P 527258

A REPAIR

## ON-SITE SEWAGE DISPOSAL SYSTEM HOWARD COUNTY HEALTH DEPARTMENT BUREAU OF ENVIRONMENTAL HEALTH

ADDRESS: 6722 Montell Drive PROPERTY OWNER: Alan Fetting Trustee

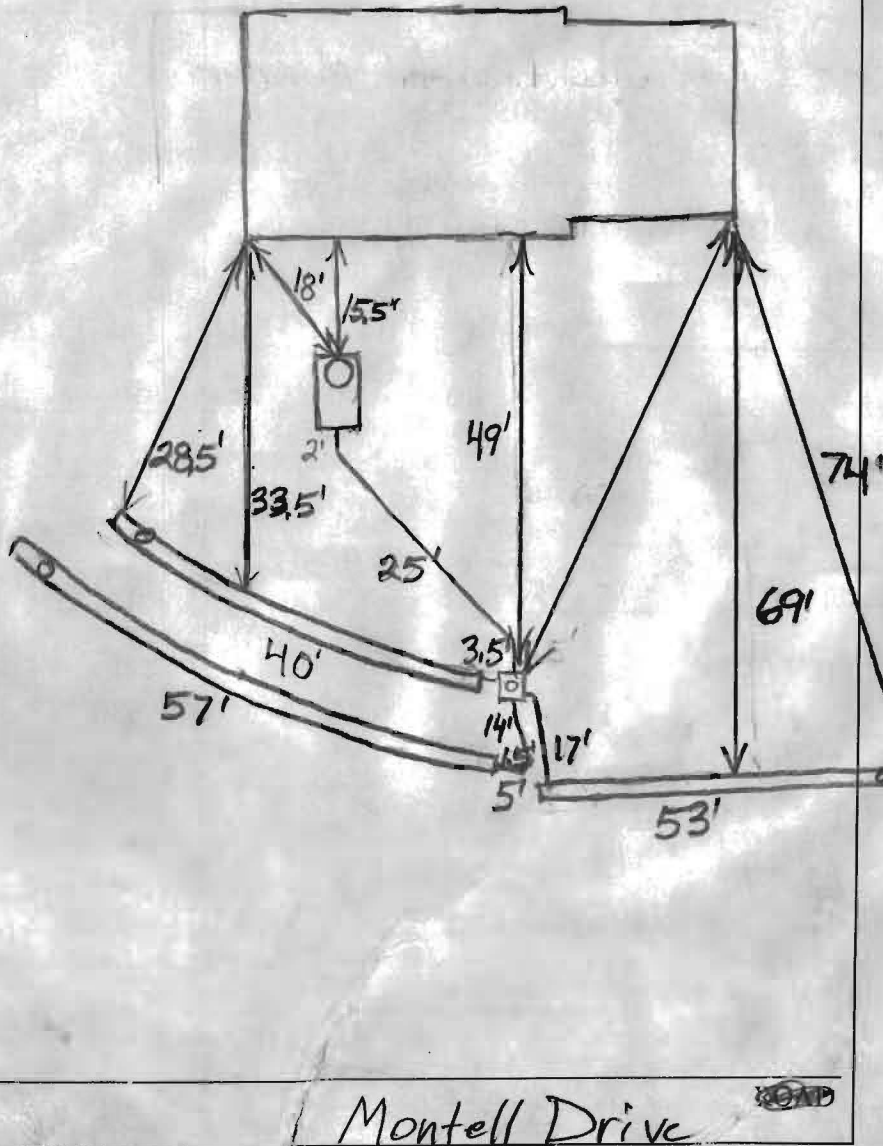
PRE-CONSTRUCTION 7/25/07 Plan the distribution box downhill of the septic tank and install 3 trenches. (BB)

INSTALLATION Two trenches should go towards driveway and one trench on contour in the opposite direction. (BB)

8/7/07 Decided to install 1 trench towards the driveway and two trenches in the opposite direction. Easier to work around bushes for installer. (BB)

8/8/07 System finished, O.K. to backfill. (BB)
